Access Compliance Report

Public Rights-of-Way

(Curb Ramps)

Intersection ID: 14596	Main Street: SOUTH_BV	Cross Street: MAGNOLIA_AV	Location: E
ADA ID: 4590A062E0B6	Ramp Type: PerpDiag	Initial Pass/Fail: Fail	Overall Compliance: No
Severity Score: 13.75			
Codes/Mitigation Info/Possible Solution		Field Measurements/Component Compliance

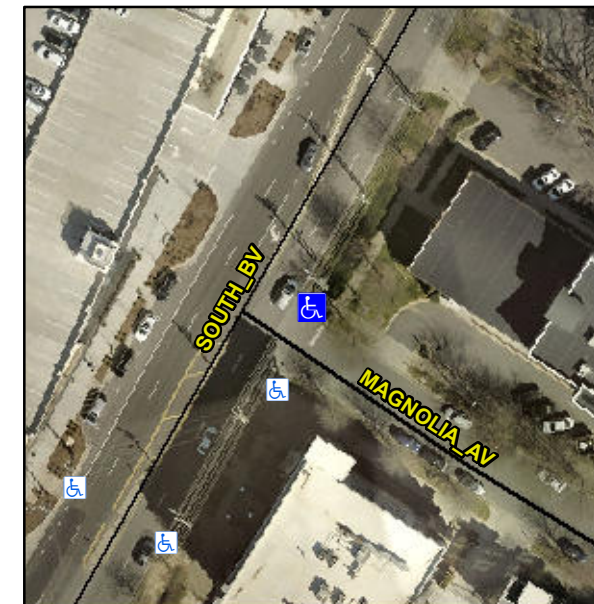
Not Found, R304.2.2, R304.5.3

Compliance	Description	Data	Compliance	Description	Data
N/A	Ramp Length (in)	52.5	No	Ramp Slope (%)	9.8
Yes	Ramp Width (in)	49.0	No	Ramp XSlope (%)	3.8
N/A	Flare Type LT	N/A	N/A	Flare Type RT	N/A
N/A	Flare Slope LT (%)	N/A	N/A	Flare Slope RT (%)	N/A
N/A	Flare Traversable LT?	N/A	N/A	Flare Traversable RT?	N/A
N/A	Landing Length (in)	N/A	N/A	DWS Provided?	N/A
N/A	Landing Width (in)	N/A	N/A	DWS Contrast?	N/A
N/A	Landing Slope (%)	N/A	N/A	DWS Length (in)	N/A
N/A	Landing X Slope (%)	N/A	N/A	DWS Full Width?	N/A
N/A	Landing Curb? (Y/N)	N/A	N/A	DWS Offset (in)	N/A
N/A	Shared Landing?	N/A			
N/A	Gutter Ponding?	N/A	N/A	Gutter Slope (%)	N/A
N/A	Gutter Lip Ht (in)	N/A	N/A	Gutter X Slope (%)	N/A
N/A	Painted X Walk1?	No	N/A	Painted X Walk2?	No
	X Walk 1 Direction	To NW		X Walk 2 Direction	To SW
N/A	X Walk 1 Width (in)	N/A	N/A	X Walk 2 Width (in)	N/A
	X Walk 1 Slope (%)	6.9		X Walk 2 Slope (%)	2.9
	X Walk 1 X Slope (%)	4.6		X Walk 2 X Slope (%)	2.4

N/A	Ramp inside XWalk1?	N/A	N/A	Ramp inside XWalk2?	N/A
	Road Slope (%)	1.9	N/A	Clear Space?	N/A
	Road X Slope (%)	6.0	N/A	Clear Space to XWalk (in)	N/A
N/A	Any Obstructions?	N/A	N/A	Storm Grate/Utility Hazard?	N/A
	Obstruction Type			Storm Grate/Utility Type	
		N/A			N/A
			Yes	Surface Condition? (G/P)	Good

Remove & Replace Curb Ramp With Two New Directional Ramps or Equivalent.
